SERVICE LETTER

No. 682B

Piper Aircraft Corporation

Required Inspection of Part No. 69650 Piston Pin -- reference attached Lycoming Service Bulletin No. 367D, dated March 8, 1974.

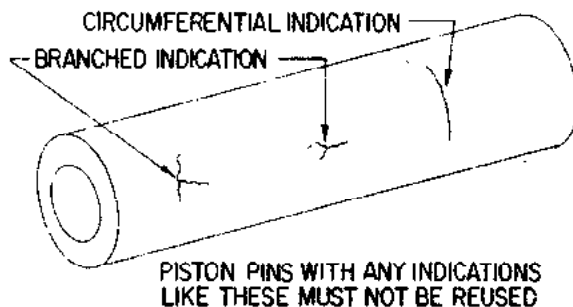
Owners and operators having access to magnetic inspection facilities may inspect their piston pins locally rather than return them to Avco Lycoming. The accompanying figure shows the type of indications that may be encountered and the following procedure describes the method of inspection to be used.

6. Use a 5-power magnifying glass to examine the piston pins. Pay particular attention for indications around the circumference of the pin; branched indications as shown in the figure are conclusive evidence of unsatisfactory pins.
